Event Center Re-Roof and HVAC Replacement
Hoover High School, Fresno, CA

TETER Project No.: A 18-10805 D

- 5 – 01: Pre-Bid RFI 6:** See attached RFI, with responses – **AD5-A01** and **AD5-A02** drawing.
- 5 – 02: Roofing at parapet walls:** Where roof turns up onto parapet wall, roofing shall be cap sheet over 2 ply sheets set in mastic to wall.

(Low) 1 2 3 4 5 (High)Specification: 070150, 076200, 079500Addendum: 2Subject: Clarifications at Expansion Joint & Sheet Metal Counter Flashings

PROPOSED ROOF PLAN

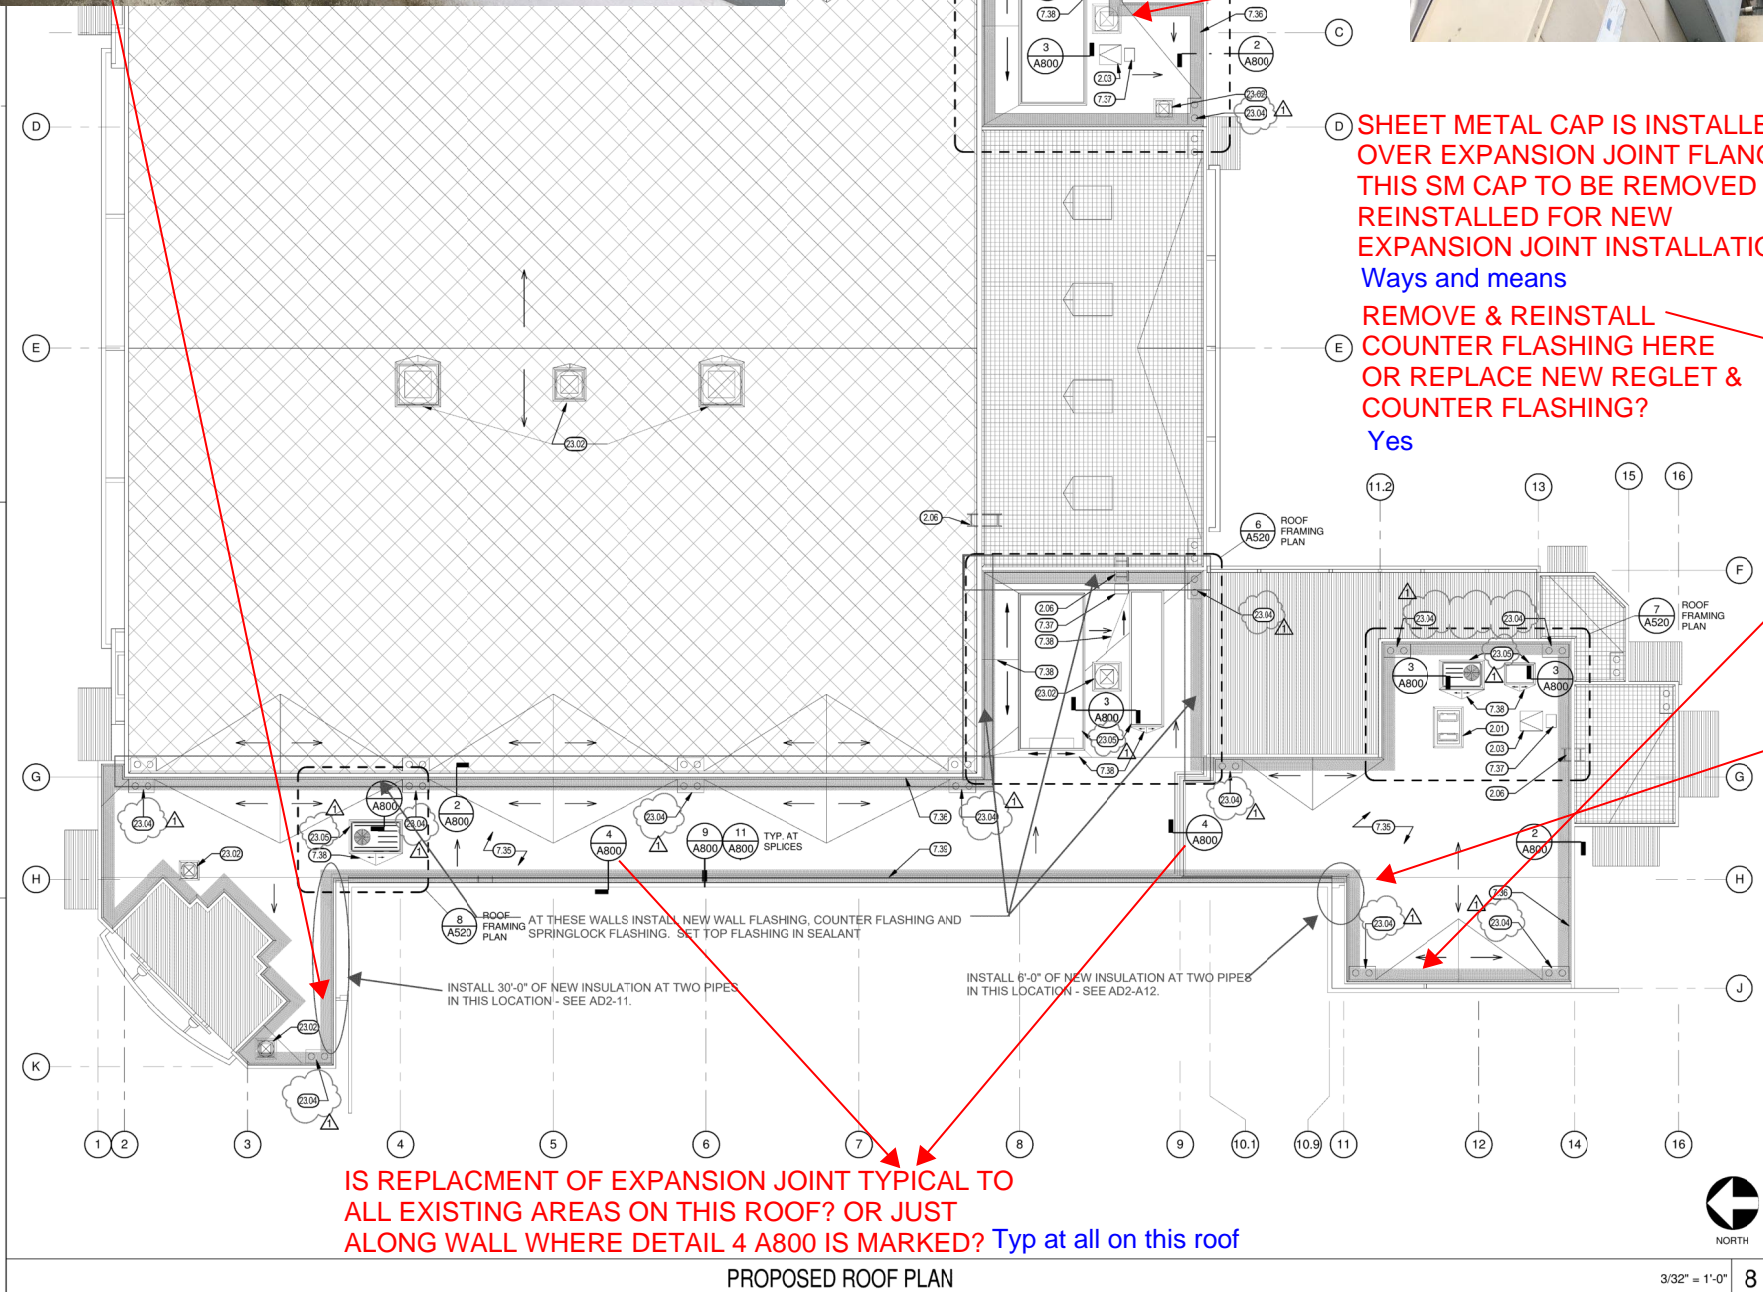
IS SHEET METAL CAP TO BE REMOVED & REINSTALLED TO INSTALL NEW EXPANSION JOINT OR LEAVE IN PLACE?

IS THIS SURFACE MOUNT REGLET TO BE REPLACED NEW PER ADDENDA PLAN NOTES, IS THIS TYPICAL OF ALL REGLET COUNTERFLASHING @ TILT UP/CONCRETE WALLS? Remove and reinstall at concrete walls only, as noted

HORIZONTAL FACE OF EXPANSION JOINT NEEDS TO BE EXPOSED TO REMOVE FASTENERS & INSTALL NEW FASTENERS.

EAST LOWER ROOF REMOVE & REINSTALL COUNTER FLASHING HERE OR REPLACE NEW REGLET & COUNTER FLASHING?

SHEET METAL CAP IS INSTALLED OVER EXPANSION JOINT FLANGE IS THIS SM CAP TO BE REMOVED AND REINSTALLED FOR NEW EXPANSION JOINT INSTALLATION? Ways and means

WILL PIPES AND UNISTRUT BE REMOVED ALONG THIS WALL FOR NEW EXPANSION JOINT INSTALLATION & WALL COUNTER FLASHING OR WILL NEW EXPANSION JOINT HORIZONTAL FLANGE BE COUNTERFLASHED WITH A SKIRT METAL TO EXISTING COUNTERFLASHING?

IS REPLACEMENT OF EXPANSION JOINT TYPICAL TO ALL EXISTING AREAS ON THIS ROOF? OR JUST ALONG WALL WHERE DETAIL 4 A800 IS MARKED? Typ at all on this roof

All expansion joints are to be removed and replaced

Construct sheet metal boot around column

Yes

REMOVE & REINSTALL COUNTER FLASHING HERE OR REPLACE NEW REGLET & COUNTER FLASHING? Yes

Ways and means
